HISTORIC AND DESIGN REVIEW COMMISSION

August 07, 2019

HDRC CASE NO: 2019-429
ADDRESS: 207 LAUREL HEIGHTS PLACE
LEGAL DESCRIPTION: NCB 6328 BLK 1 LOT 46, E 11.2 FT OF 45 & W 38.8 FT OF 47
ZONING: R-5,H
CITY COUNCIL DIST.: 1
DISTRICT: Monte Vista Historic District
APPLICANT: Lawson Jessee/Troy Jessee Construction
OWNER: Bob Harris
TYPE OF WORK: Window and door modifications
APPLICATION RECEIVED: July 10, 2019
60-DAY REVIEW: September 08, 2019
CASE MANAGER: Stephanie Phillips
REQUEST:

1. Install a salvaged window on the west elevation adjacent to an existing door.
2. Remove four existing multi-lite wood windows and install steel windows and a door on the east elevation.

EAST ELEVATION

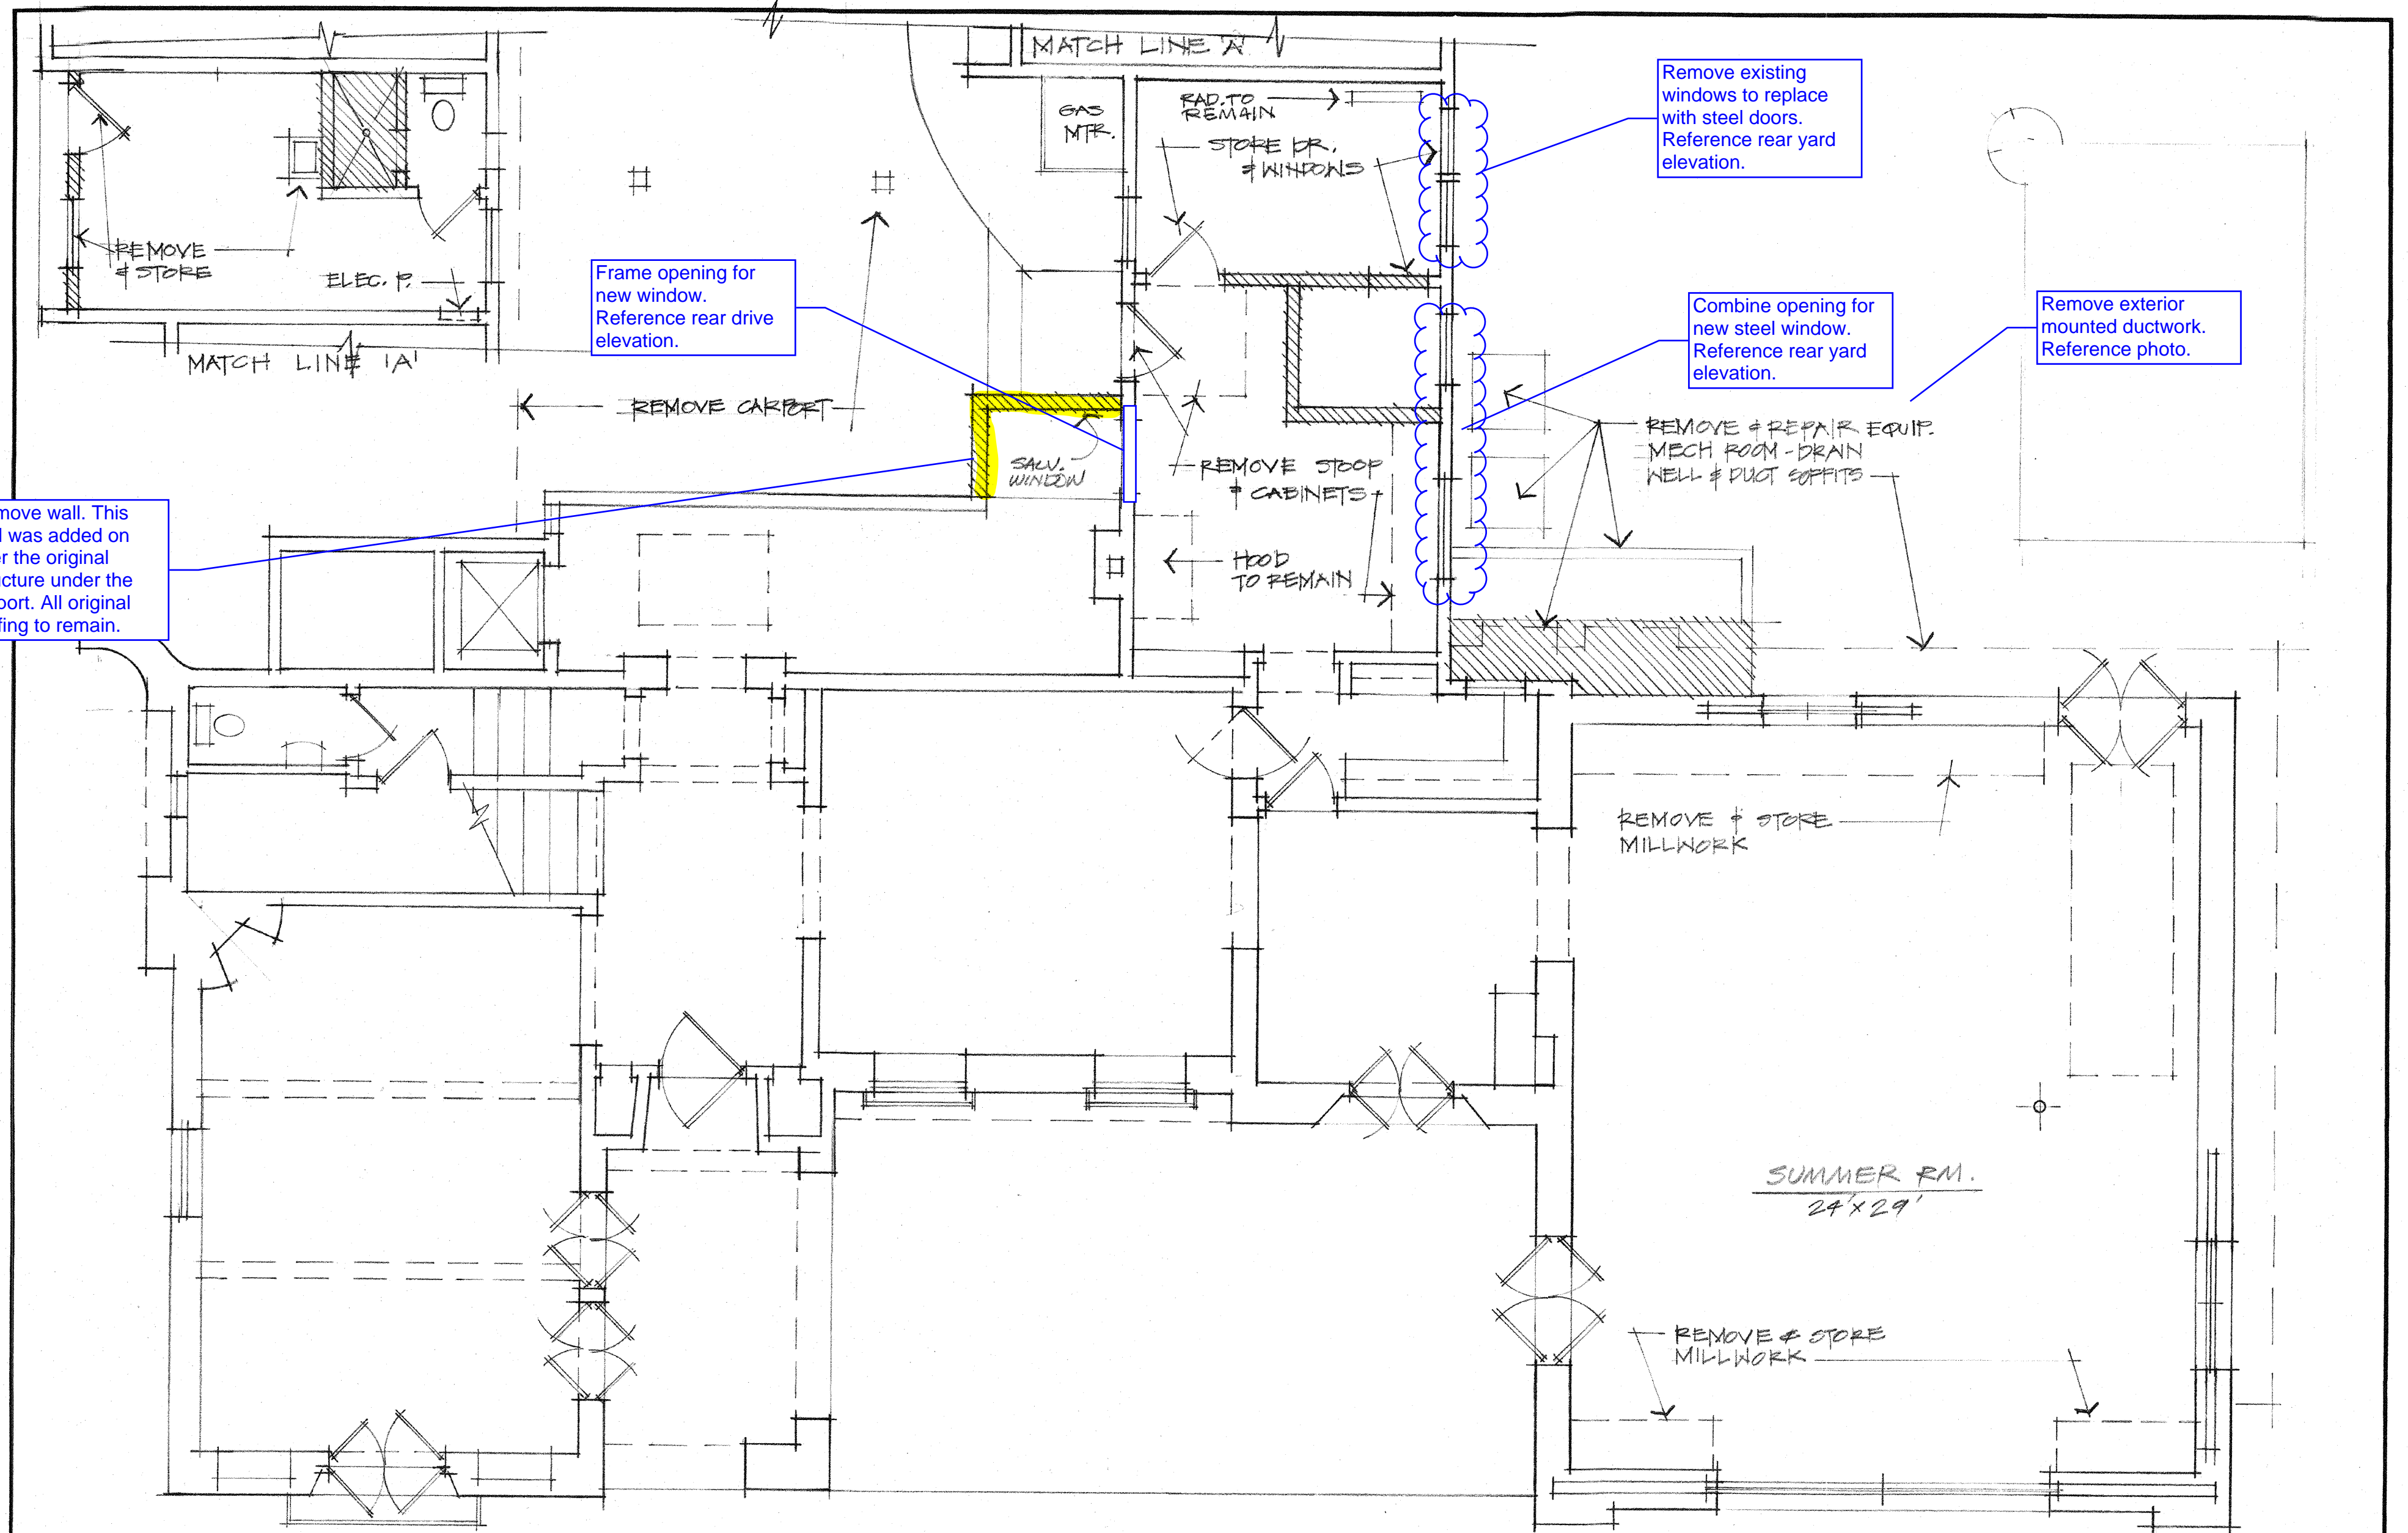
- c. FENESTRATION MODIFICATIONS – The applicant has proposed to remove four existing wood windows on the east elevation and install a steel window and door in their place. Three of the existing windows are six over six, vertical double hung wood windows. One window is four over four and has a horizontal proportion. The applicant has provided original drawings of the home, which indicate a different fenestration pattern on this elevation. Based on this evidence, the windows do not appear to be original. According to the Historic Design Guidelines, non-historic windows should be replaced with windows that are typical of the architectural style of the building. Staff generally finds the proposed fenestration modifications to be appropriate for the style of the home based on the existing windows and doors on the house and the location of the modifications, which is not visible from the public right-of-way.

Item 2, Staff recommends approval of the fenestration modifications based on finding c with the following stipulation:

- i. That the applicant salvages the window sashes and stores them on site for future repairs or donates or sells them to a local entity.

REAR DRIVE - WEST ELEVATION

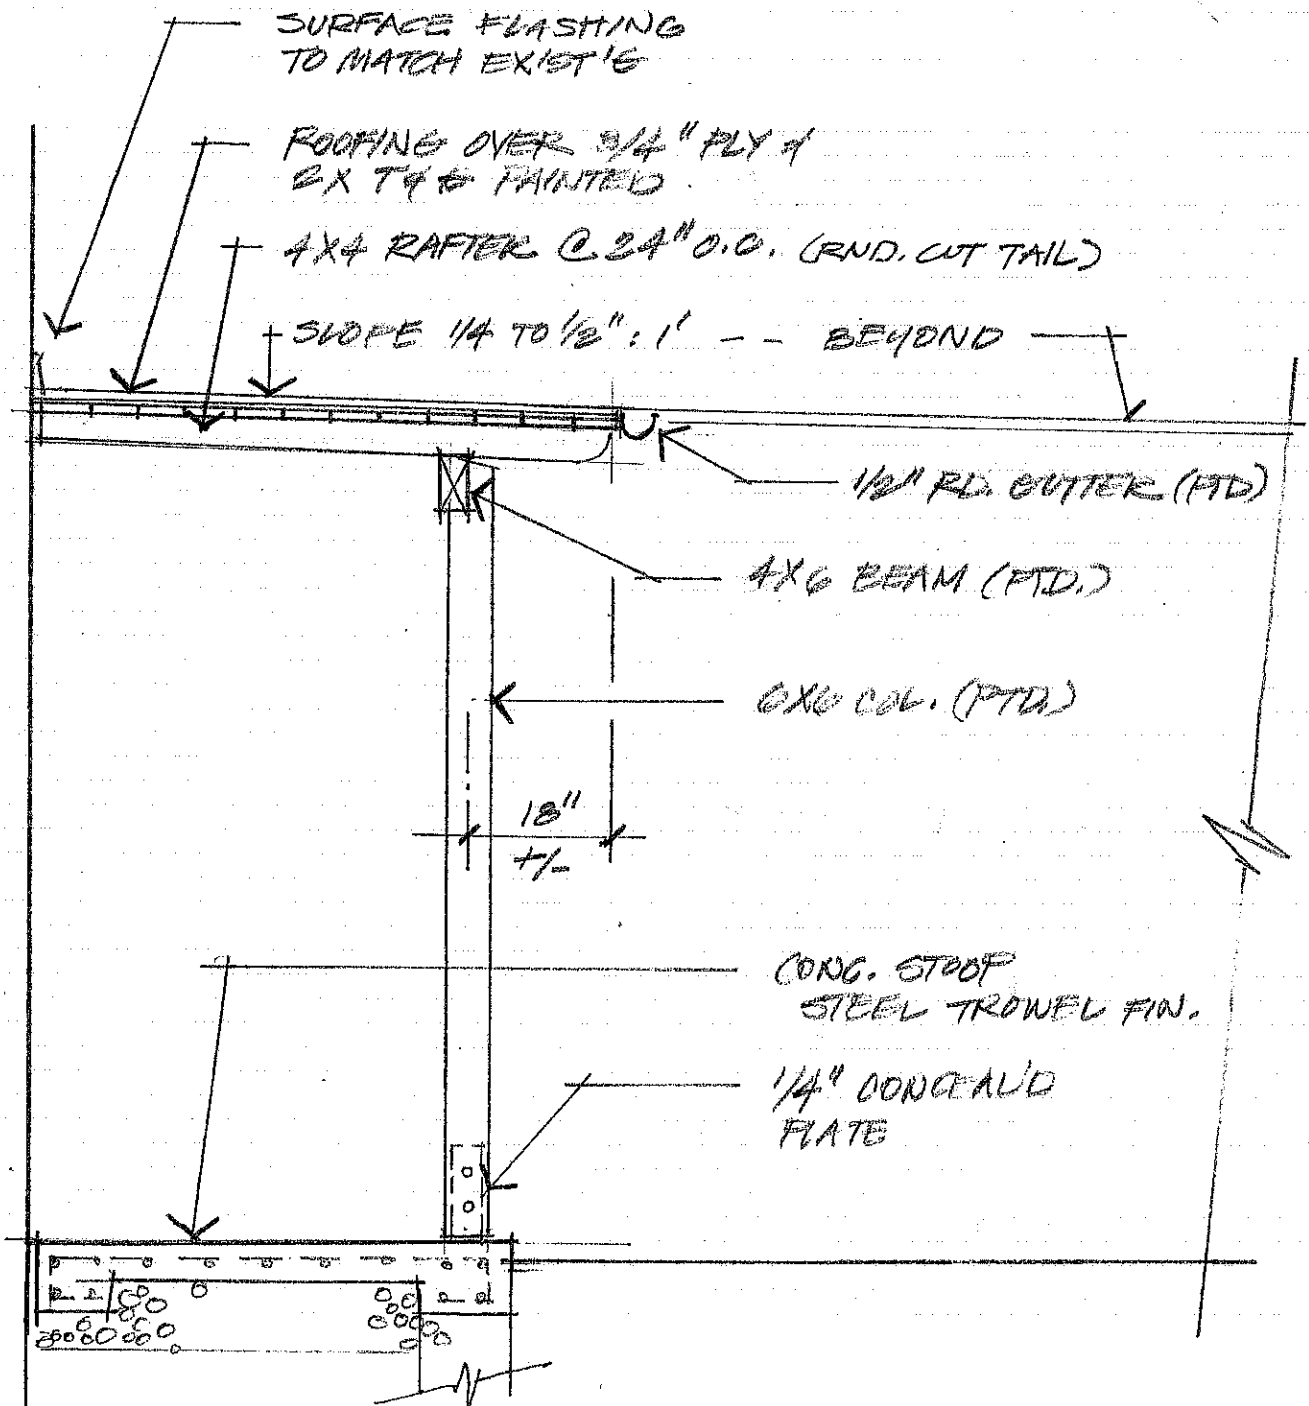
- b. SALVAGED WINDOW - The applicant has proposed to add one window opening to the west elevation adjacent to an existing door. The window will be six over six, vertical double hung salvaged from a non-original wall which was administratively approved to be removed. Staff finds the proposal appropriate.

Item 1, Staff recommends approval of the installation of a salvaged wood window based on finding b.
